10-1 – 12

Chapter 10, Chapter 11

Proponent: Ed Roether, representing the ADA/A117 Harmonization Task Group

Plan 1
Type A units

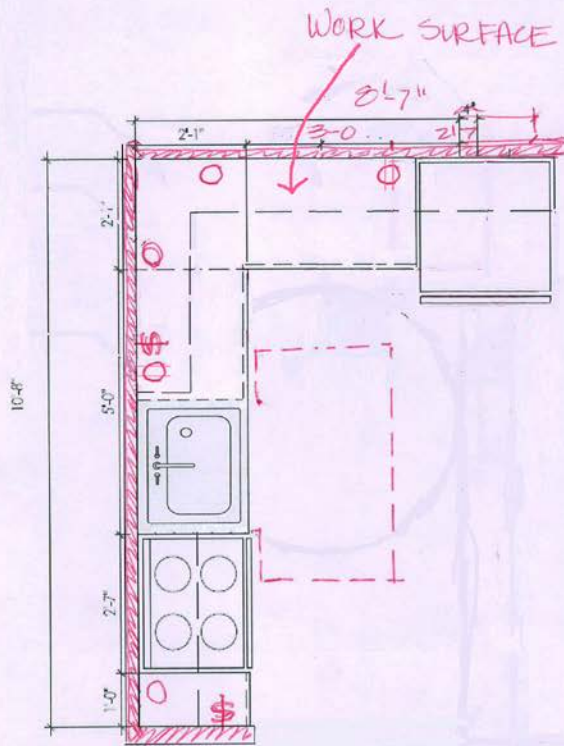
Reason: The Reach Range subgroup of the Wheeled Mobility Task Group examined the data provided by the Wheeled Mobility Research project and has attempted to use this data in conjunction with NEC requirements for outlets in kitchens and bathrooms to come up with standards that will provide the most usability as possible for outlets in Accessible, Type A and Type B units.

Following are several examples of kitchens where the group looked at compliance with the new provisions.

1002.15.3 (New)

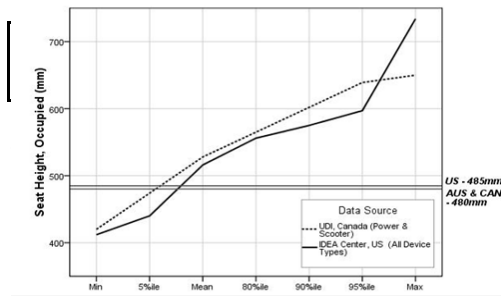
Reason: This proposal is put forth as a response to numerous comments from our membership that cite the lack of accessible beds in places of transient lodging, which makes it very difficult for people with disabilities to transfer from their mobility device to beds that are becoming increasingly higher when measured to the top of the mattress. These complaints from our membership, combined with the data released in the Final Report of the Anthropometry of Wheeled Mobility Project - Prepared for the U.S. Access Board December 31st, 2010, substantiate the need to address the height of beds in accessible hotel rooms. Increasing bed heights also adversely impact persons of short stature that have difficulty accessing these beds – which can range from approximately 25 inches to 30 inches above the ground measured to the top of the mattress.

Due to the increased heights of hotel beds over the past approximately 8 years, rooms that were once considered accessible have become inaccessible. Our proposal would require at least one bed to provide a mattress height between 19 inches and 23 inches above the ground.

1002.15.3 Bed Height. At least one bed shall measure 19 to 23 inches high from the floor to the top of the mattress, whether or not the mattress is compressed.

(d) Clearance with lavatory overlap

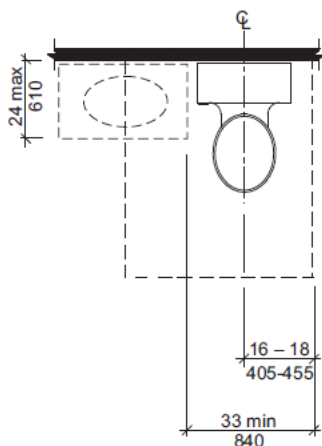
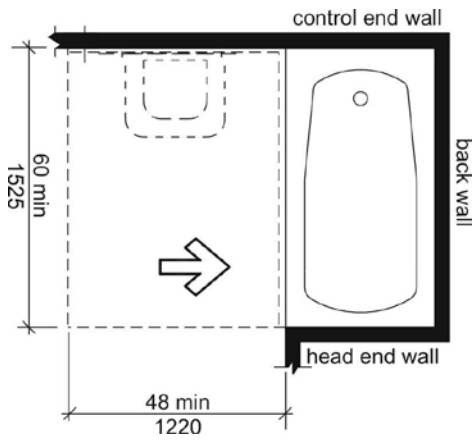
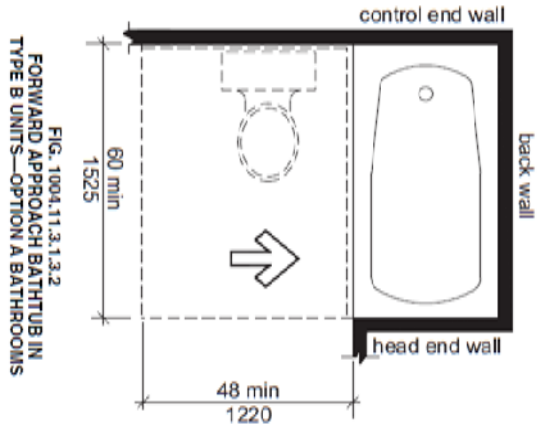
This is simply a clarification that may be helpful given several changes that occurred in the 2009 edition and dealt with the way the word “and” was used for requirements. This perceived problem may be caused by being too code literal, but the use of the word “and” as the conjunction does raise the question as to whether the encroachment is only allowed for situations where both the water closet and lavatory exist or whether the encroachment is also allowed when only one of those fixtures is within the space.

Because of the word “and” in the phrase “a water closet and a lavatory” it may be assumed to require both fixtures and not allow a water closet OR a lavatory. The word “and” is good because if you provide both a WC and a lav along the end wall you could end up with both of them extending into the required clearance (the first would be in it completely and the second would encroach just a bit based on the clearance between fixtures). [See fig. 1004.11.3.1.2(d) below for example of how both fixtures may encroach.]

Changing the word “and” to be “or” would seem like a possibility but that would not accept the second fixture extending into the space as discussed above. Because the text needs to accept either one fixture or both fixtures in the space, it may need to be changed to something like what is shown in the two options.

1004.11.3.1.3.2 Forward Approach Bathtubs. A clearance 60 inches (1525 mm) minimum in length and 48 inches (1220 mm) minimum in width shall be provided in front of bathtubs with a forward approach. Either a water closet or a lavatory or both a water closet and a lavatory shall be permitted in the clearance at one end of the bathtub.

1004.11.3.1.3.2 Forward Approach Bathtubs. A clearance 60 inches (1525 mm) minimum in length and 48 inches (1220 mm) minimum in width shall be provided in front of bathtubs with a forward approach. A water closet, a lavatory, or both a water closet and a lavatory shall be permitted in the clearance at one end of the bathtub.
